TOWN PLANNING BRANCH
 APPROVED / NOT APPROVED
 APPROVED subject to the attached conditions.
 CITY ENGINEER 2-2-87
 PLANNING COM.

AS BUILT

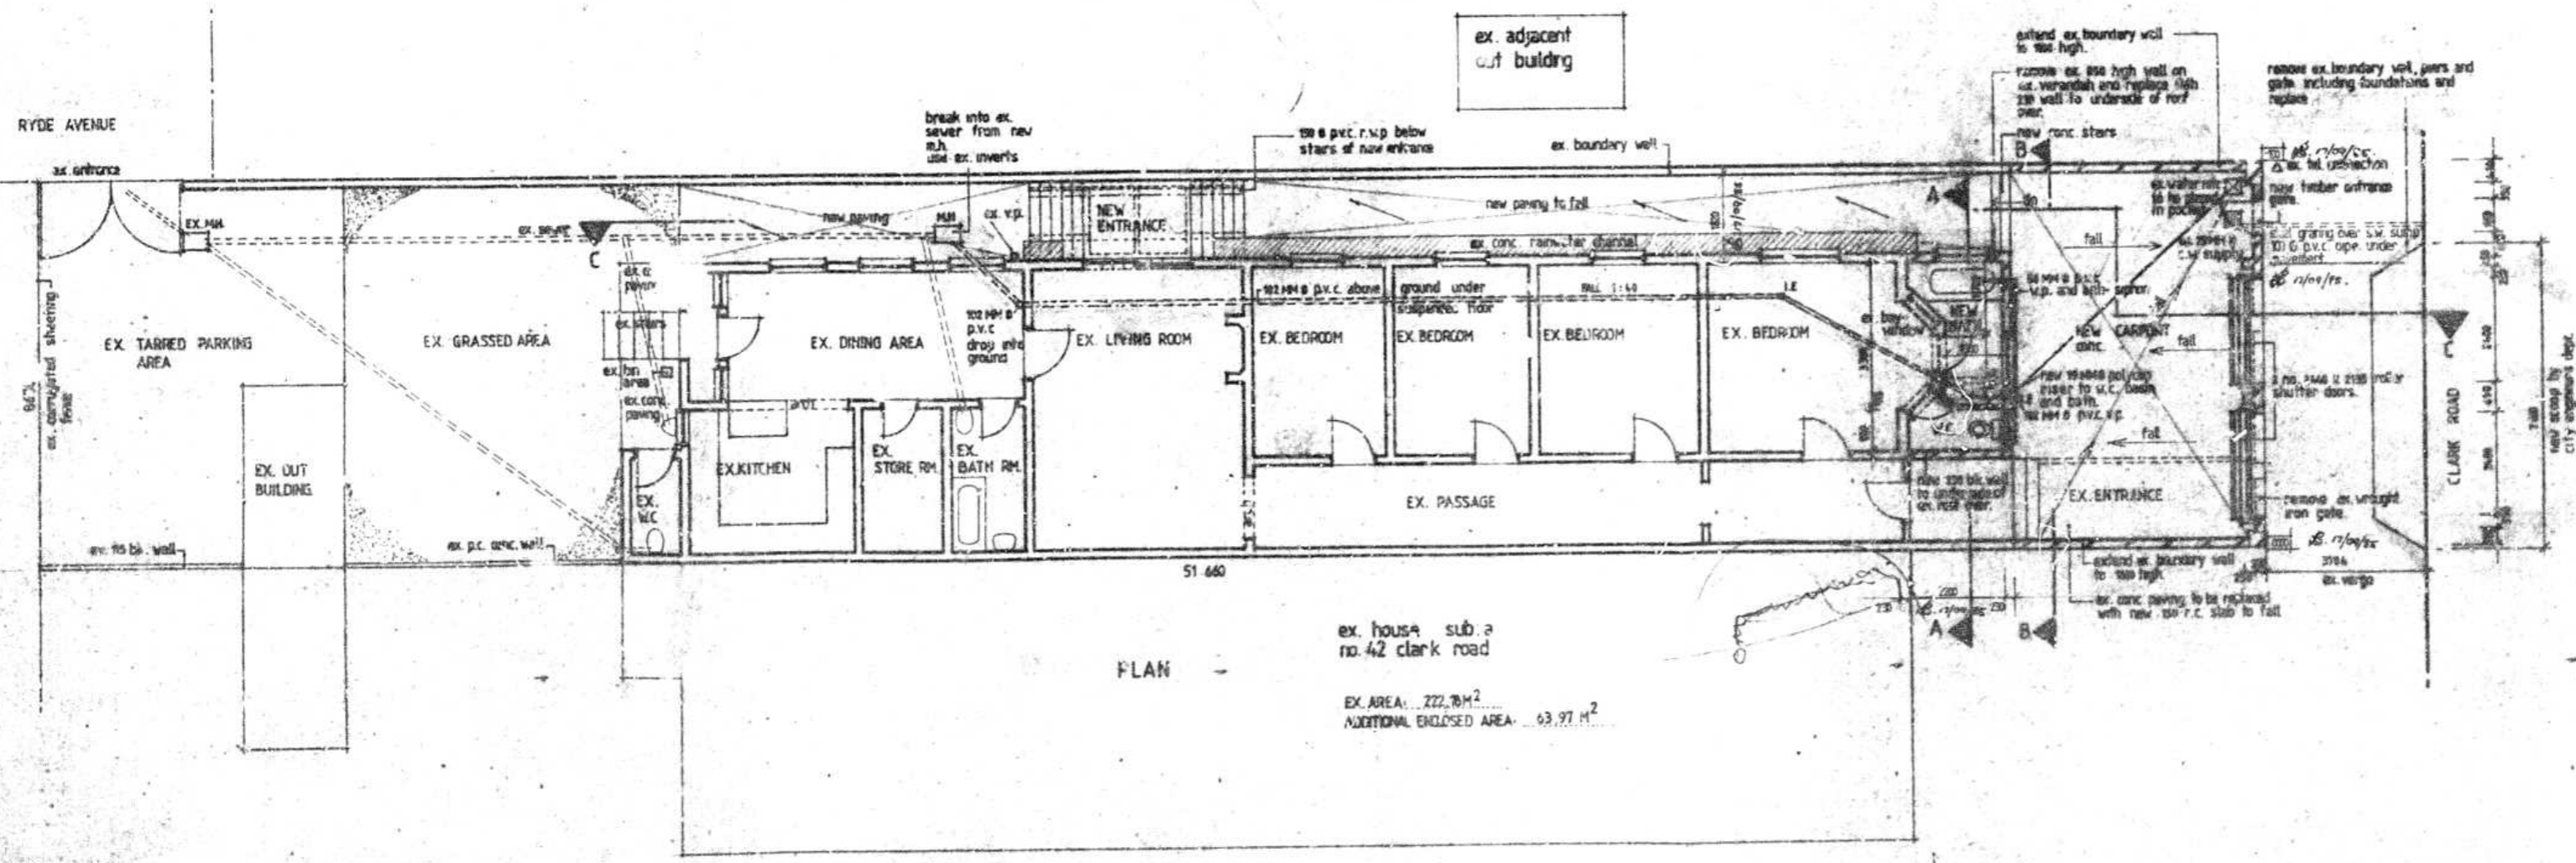
Applicant to ensure that entrances/exits are not obstructed by municipal services or trees.

CONCRETE DELTA AT CORNER FRONTSAGE LEVEL REQUIRED AT ENTRANCE/WALL

SCOFFRAGE LEVEL REQUIREMENTS
 Tops of foundations of any frontage walls to be at least 0.230m below the levels given below.
 Where no level is recorded, foundations shall not be higher than the nearest edge of the adjacent kerb-road end.
 Vehicular and pedestrian entrances on the road reserve boundary shall be constructed on the same grade as the kerb or road and shall be at least 0.10m above the level of existing footpaths/verge OR (B) be at a level
 (i) above the nearest existing kerb OR
 (ii) above/below the nearest edge of the kerb/road.
 Date: _____ Signature: _____
 It is confirmed: (A) Existing frontage level in order. (B) Existing frontage level NOT IN ORDER. (C) Underlying form to be submitted.
 Date of Second Circulation: _____ Signature: _____
